# Response to Utah Party Comments on PacifiCorp's Integrated Resource Plan

(Docket No. 05-2035-01)

This document provides a summary of the substantive comments submitted by the parties, along with PacifiCorp's responses.

The charts below compare Calendar Year gas prices for the reference and high gas scenario cases with the Company’s gas price forecast as of the end of December 2004 (CG26) and PacifiCorp’s latest March 2005 forecast (CG27).

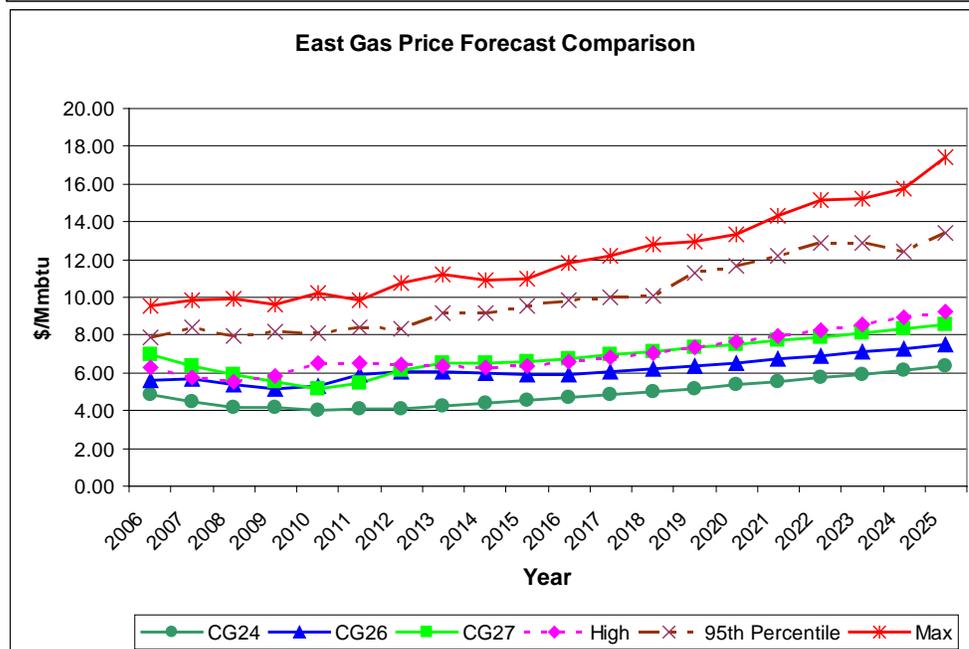
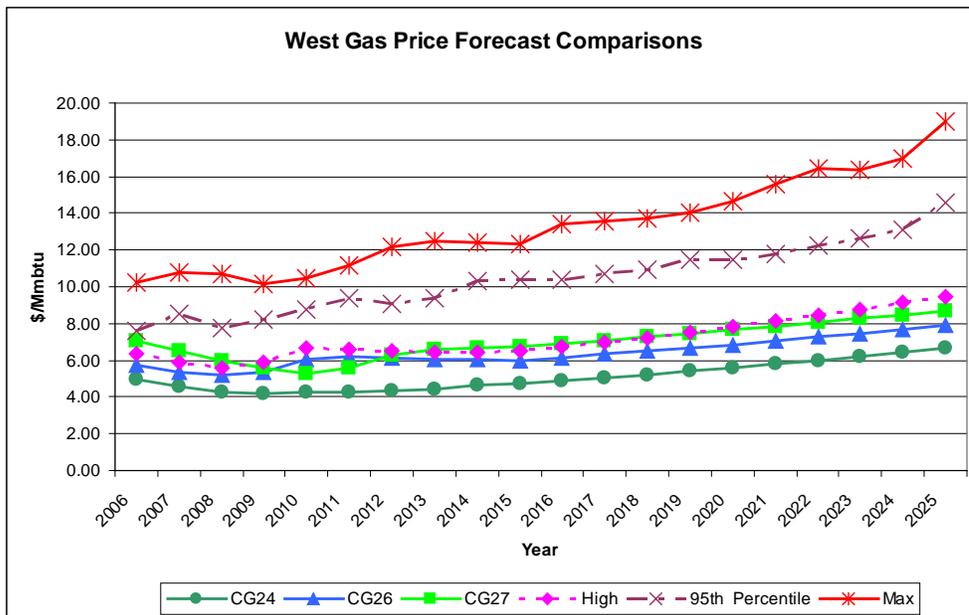
Most of the parties view PacifiCorp's decision to not update the entire IRP analysis using the December 2004 gas price forecast as a major modeling flaw. Several of the parties contend that this flaw essentially invalidates the IRP by biasing the simulation results in favor of gas-fired resources over other alternatives. CCS, UAE, and Mountain West stated that PacifiCorp's June 2004 base case natural gas price forecast is too low in light of recent gas market developments or other forecast sources, and criticize PacifiCorp for not redoing the portfolio analysis using the December 2004 forecast. UAE stated that the relationship between gas and contract prices, especially at high prices, was not well explored; it advocates additional sensitivity/stress case analysis. CCS notes that the gas price forecast used for the high gas price scenario was not sufficiently extreme. DPU is unclear on why two gas price forecasts—IRP Base and PIRA—are needed to express the gas price increases for the high gas price scenario.

Some criticisms to the IRP results are based on not using one of the higher, more recent forecasts of natural gas prices.<sup>1</sup> These criticisms are not valid nor are they reason to withhold acknowledgement of the IRP for several reasons. First, the IRP did, in fact, use a range of natural gas forecasts and stochastic analysis to verify the validity of the Preferred Portfolio under higher natural gas futures. Moreover, the IRP analysis concluded that the decision on the first supply resource is actually independent of which natural gas forecast is used. Finally, the course of action recommended by those parties is impractical, if not impossible, and not compatible with a reasonable IRP process. For these reasons, as explained in greater detail below, the IRP results are valid and consistent with the recent trend of natural gas prices.

As illustrated, the high gas case scenario is higher than the December updated forecast, and higher than the most recent update. While some parties have argued that the high gas case isn't sufficiently above the updated forecast to be called extreme, those arguments ignore the much higher gas cases that were considered as part of the stochastic analysis.

The attached graphs also illustrate the maximum value of the 100 iterations for the gas prices and the 95th percentile value of the gas prices according to the stochastic analysis. As indicated by the graphs, both the maximum gas price forecast and the 95th percentile gas price greatly exceed the values of the high scenario gas price forecast and the CG27 price forecast. It should be noted that the 95th percentile is 48% (20 year average) higher than CG27, and therefore is clearly within the suggested high gas price scenario of 20% higher than CG27.
